## **Structural**

### **1 RAI 1-1:**

SAR Figure 7-15 Comparison of gamma source strengths for PWR and BWR fuel assemblies with the source terms calculated in SAR Table 7-38 and RN-09-10-NCS-45

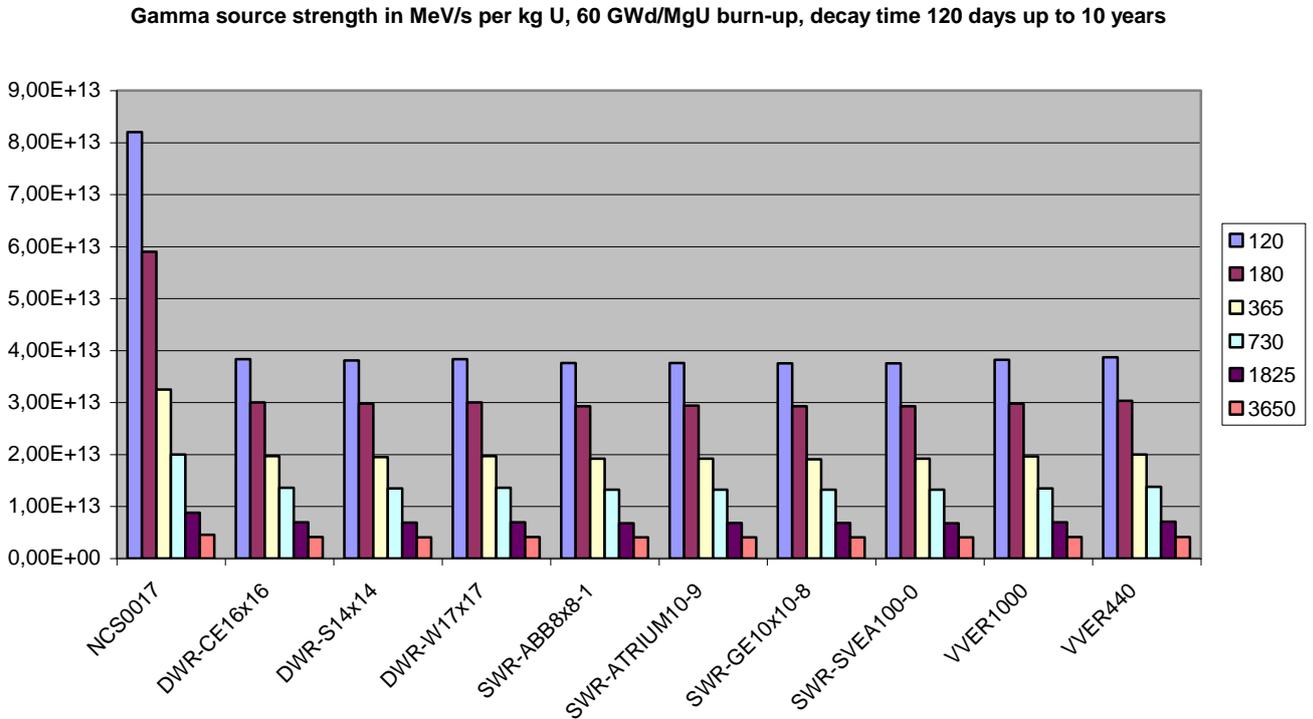
The resulting source terms are compared with source terms calculated with the depletion code ORIGEN-ARP for burn-up values up to the currently implemented value of 70.5 GWd/MgU. For easy reading the respective figures from the SAR, Figure 7-15 and 7-16 are repeated. This figures show in the first multicolumn (designated with NCS 0017) the source terms used in the SAR and in calculation note RN-09-10-NCS-45 and in the following column the source terms for typical PWR, BWR and VVER fuel assemblies. This comparison shows that the source terms calculated here are conservative envelopes for the variety of existing fuel assembly designs.
